**Committee of the Whole
Meeting Minutes
Tuesday, August 25, 2026
8:30 AM**

Prime Contract Change Order #003: RFI #8: Gymnasium - Chimney Demolition Concealed Conditions

Prime Contract Change Order #004: CE #022 - RFI 15 & 17 Electrical Changes

Prime Contract Change Order #006: CE #018 - RFI #14: Auditorium - ADA Elevator Access and Ramp

LENOIR HIGH SCHOOL GYMNASIUM
CHIMNEY DEMO CONCEALED CONDITIONS

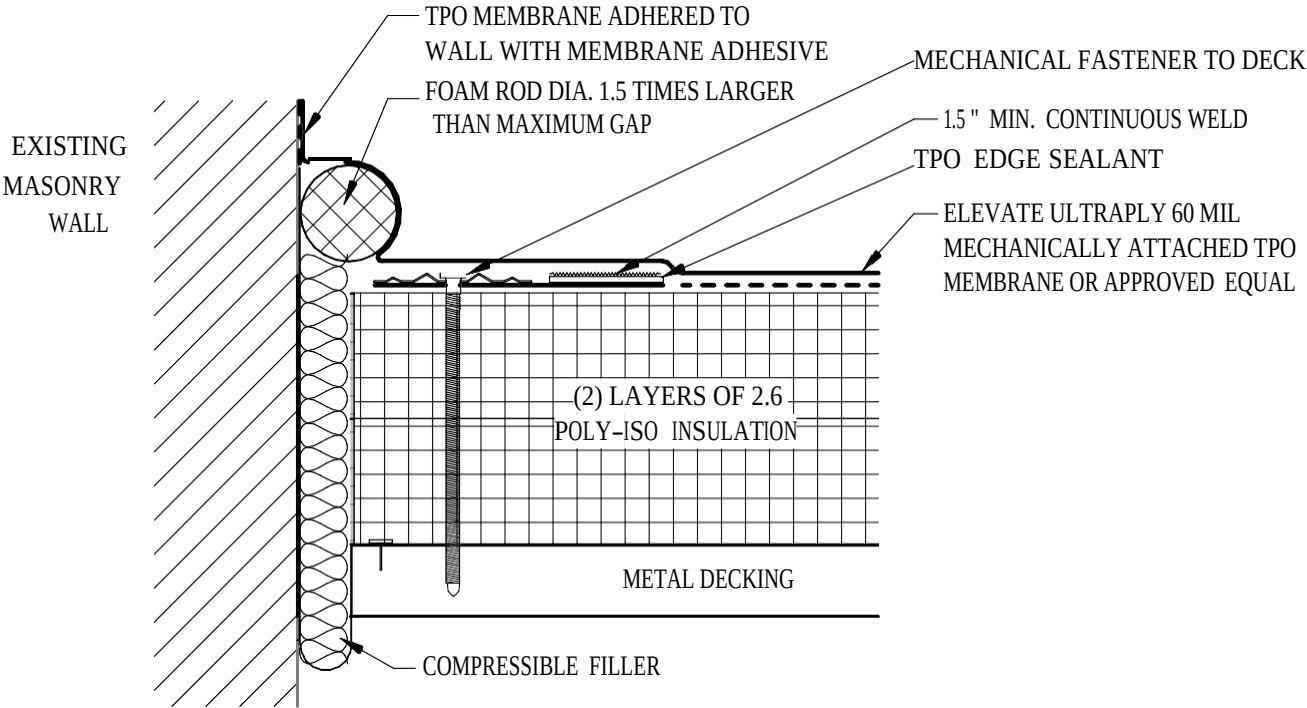
The following change request is for the added wall furring, brick, and steel lintel needed due to the demolition of the existing chimney per drawings RFI 8.1 dated 3/3/2026, RFI 8.2 dated 3/3/2026, and SBD1 dated 3/17/2026.

Change Event is for the added partition walls, brick, and steel lintel needed due to the demolition of the existing chimney.
 Please review and provide pricing, feedback, comments.

FURRING TO TERMINATE
INTO SIDE OF PILASTER

ELECTRICAL
DEMOLITION PLAN

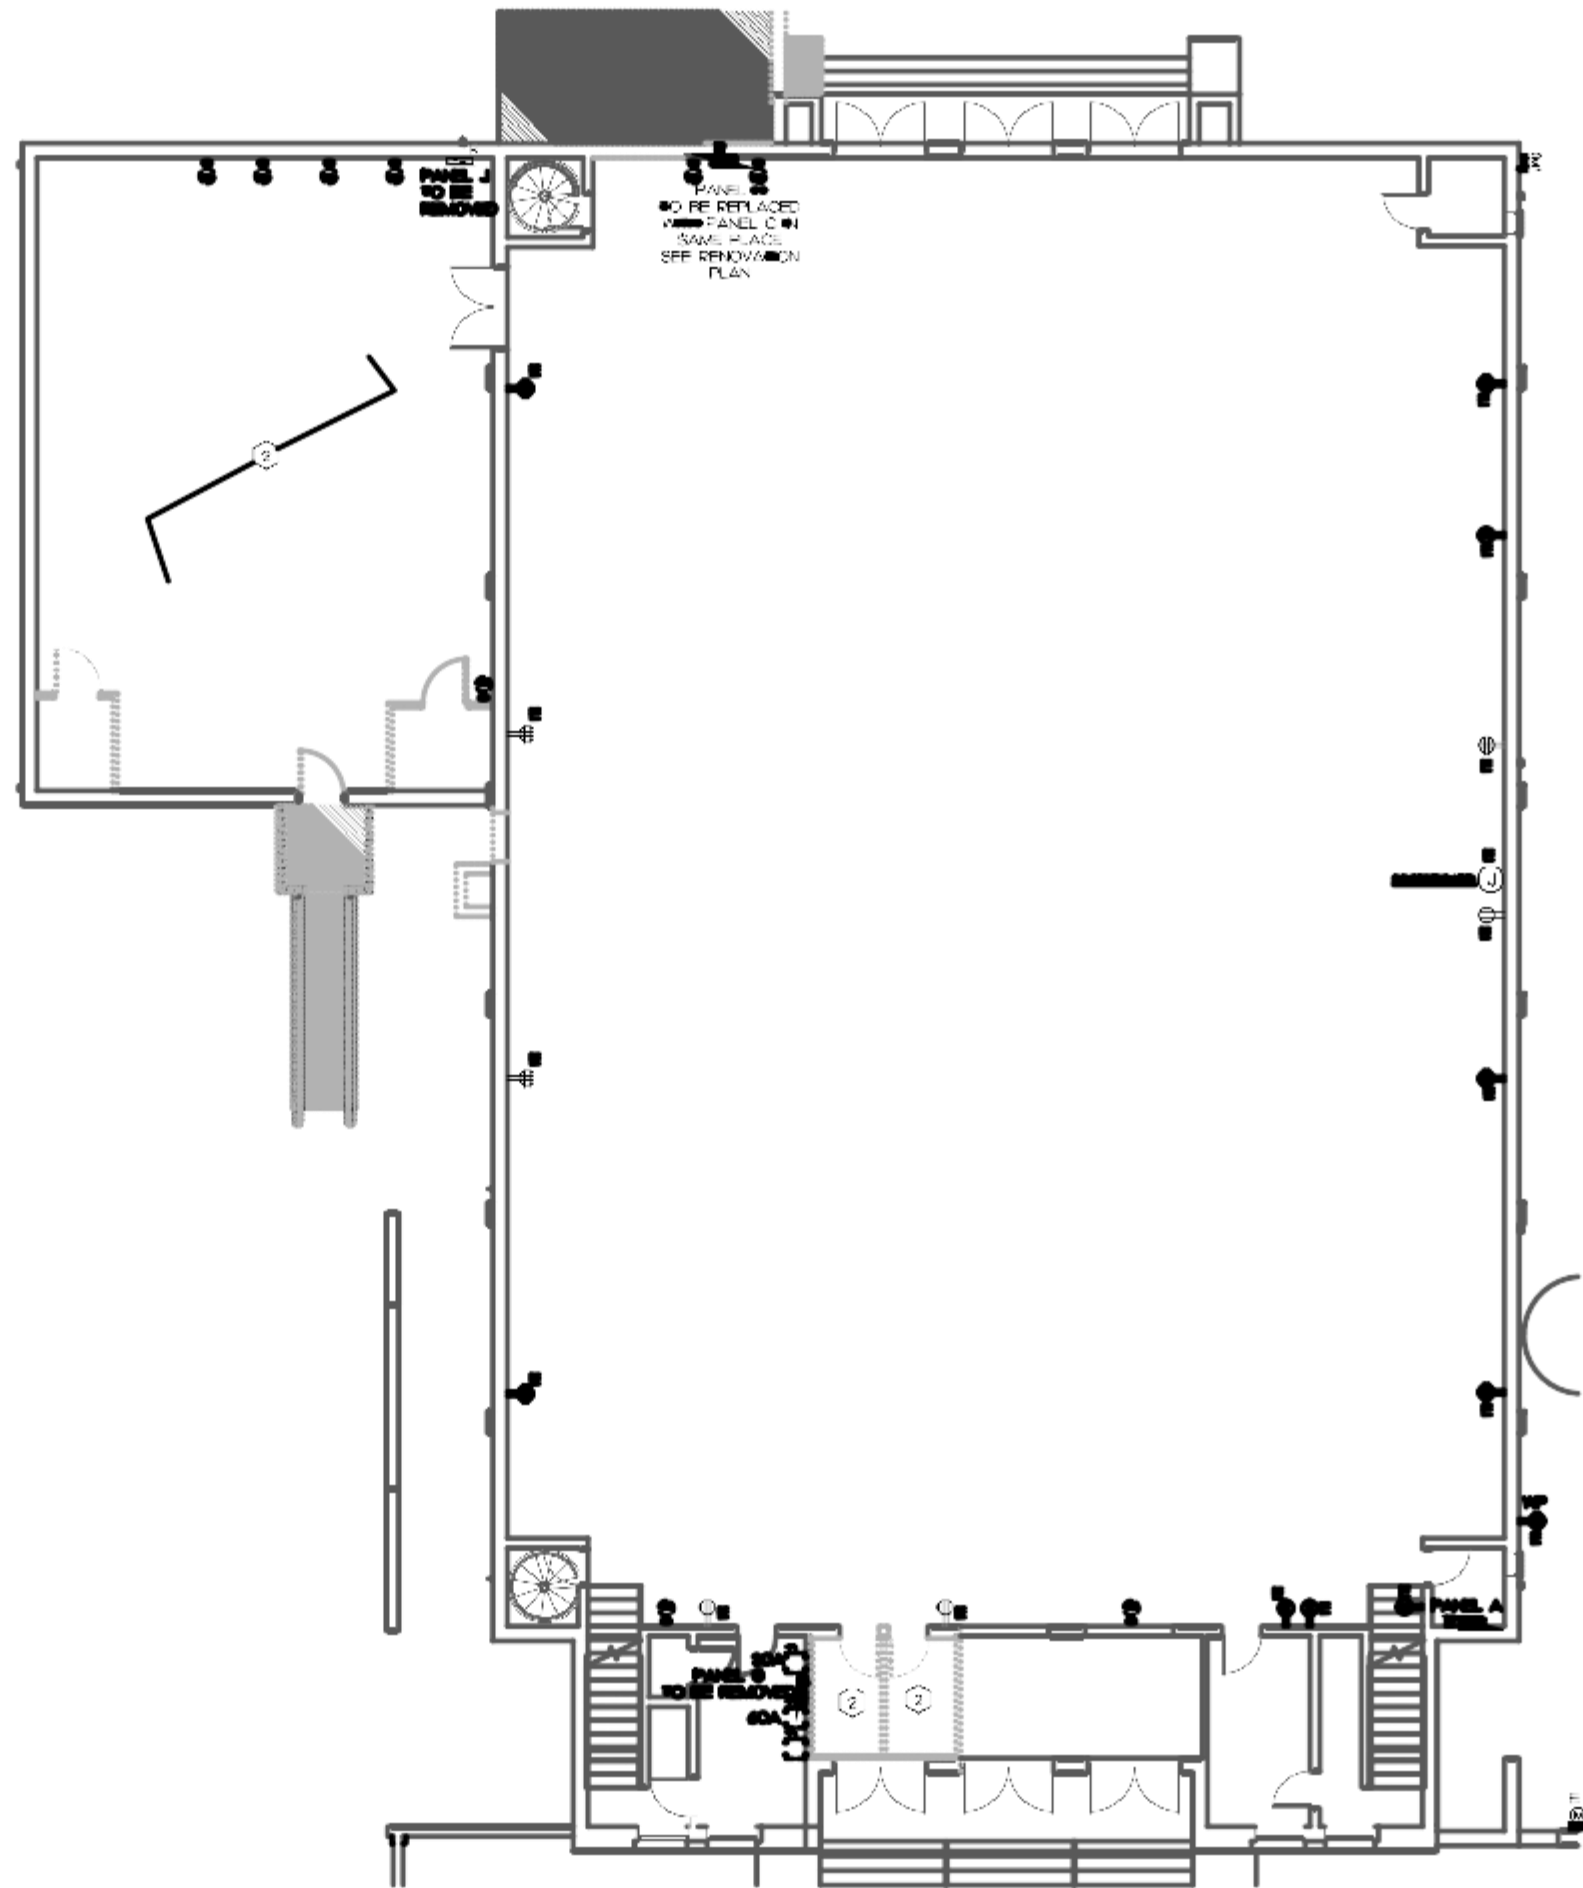
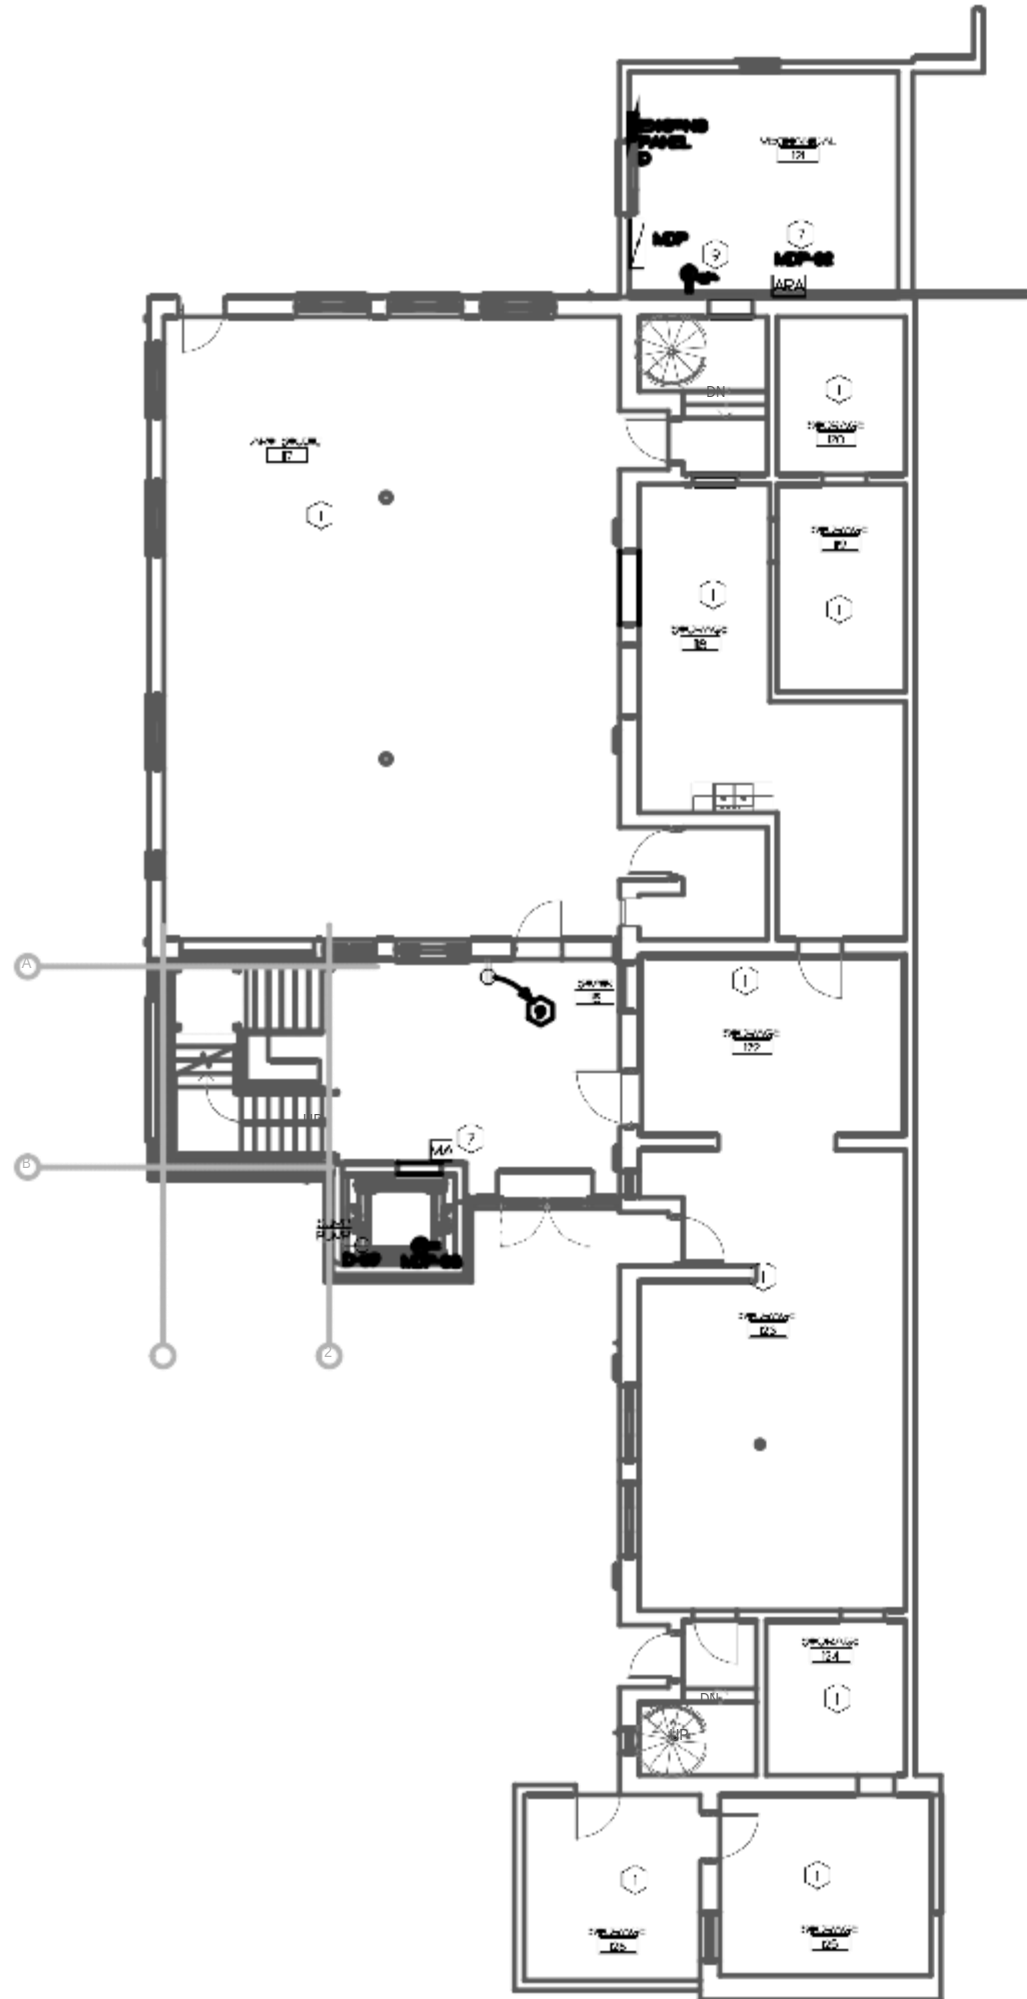
Owner has requested to remove the Panel A out of Room 009 in the plan south side of the building, and have everything included in Panel C in the plan north of the Contract Drawings.

Owner has requested to remove the panel A out of room 009 in the plan south side of the building, and have everything included in panel C in the plan north of the drawings.

E1.0: Replace existing receptacles with new in place. See renovation plan.

Per discussions with ownership, we'll move forward with remove the additional electrical service. Will refeed panel A from panel C. Service will be close to capacity, but can add additional panel in future if need arises.

REVISED RAMP PLAN

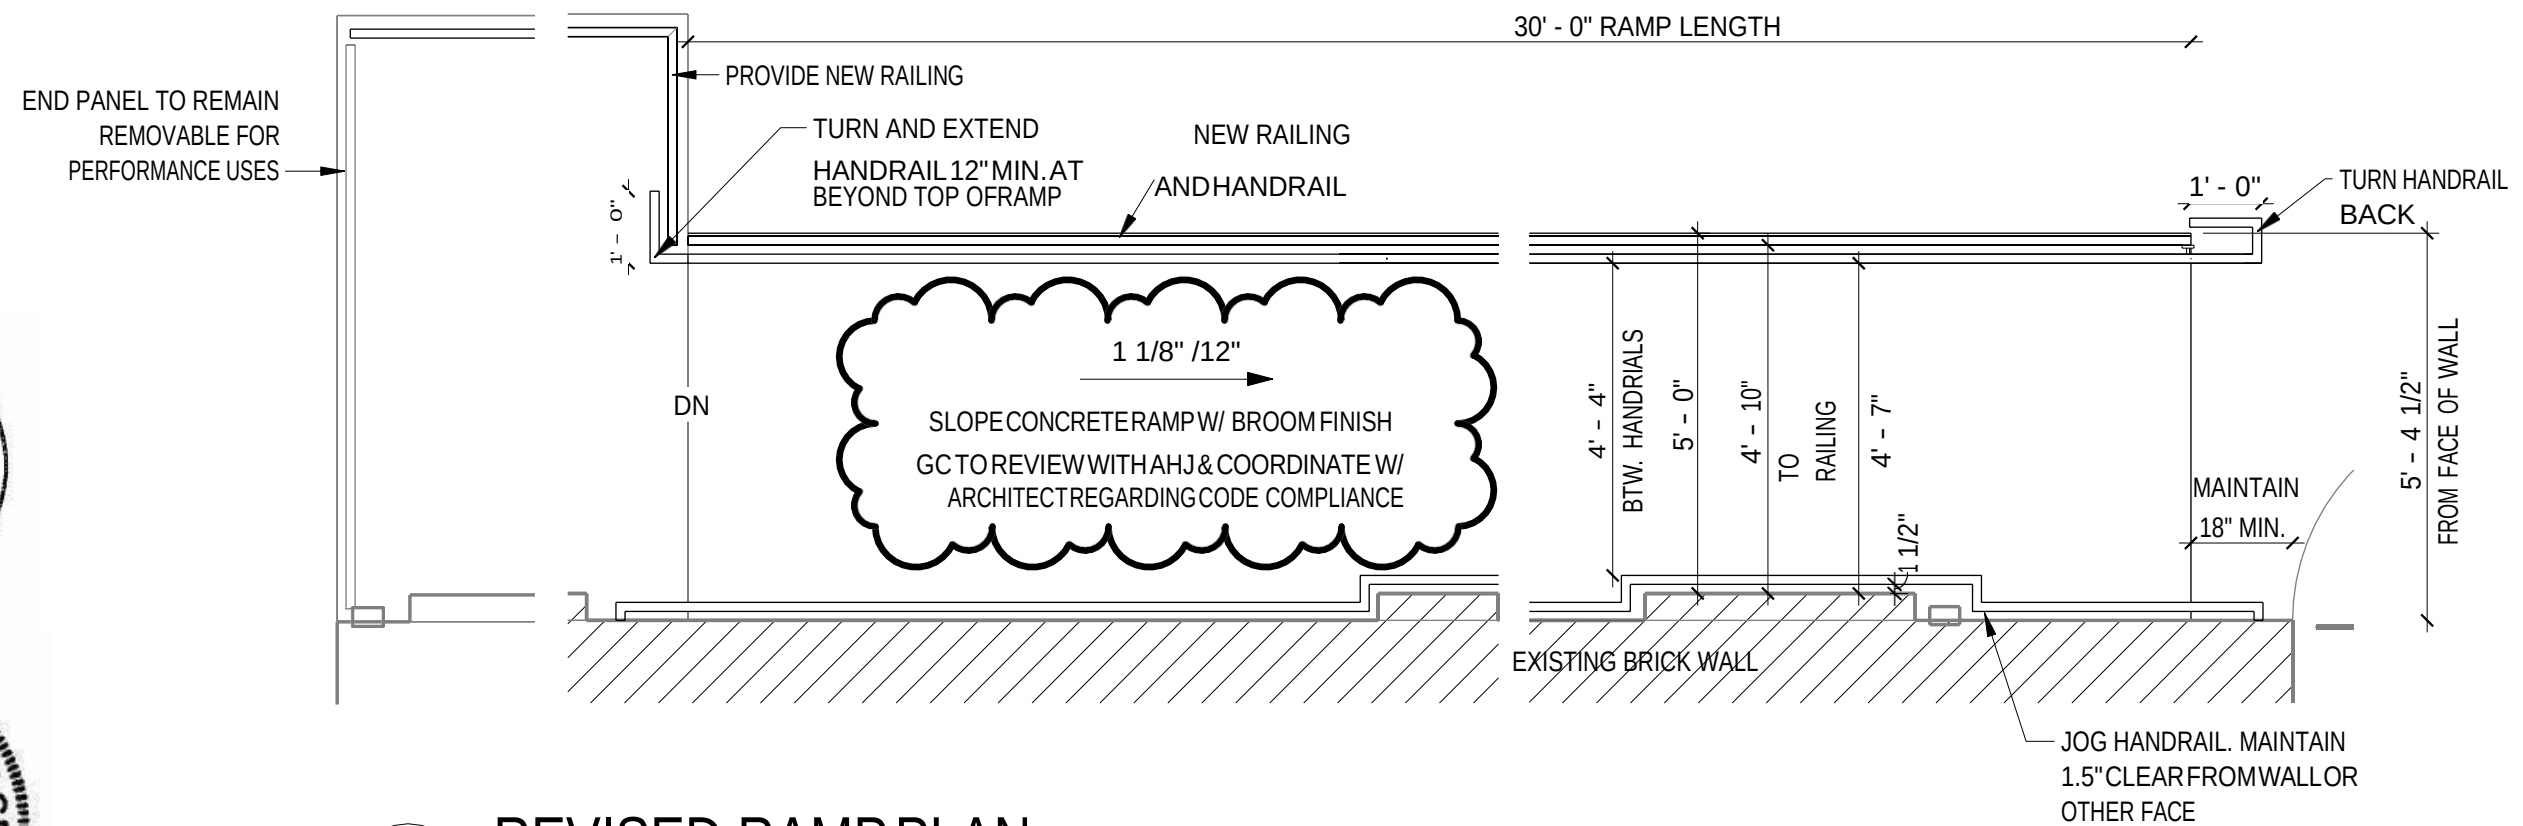
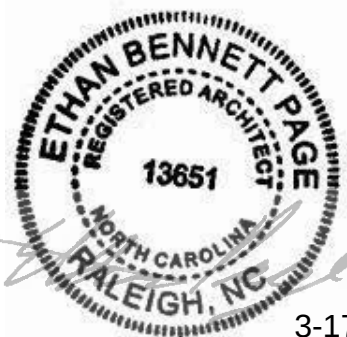
Change Order is for eliminating the wheel chair lift inside of the auditorium, and increasing the size of the exterior ramp as shown in the B-1 bulletin drawing "Exterior Ramp Revision".

Change order also includes revisions to hand rail by removing remaining existing rail as shown on B-1 and additional railing length and new profile to include pickets spaced no larger than 3.5".

Per response to RFI 14 Inspector has approved ramp design on the exterior of the north side of the auditorium to have a slope greater than 1:12.
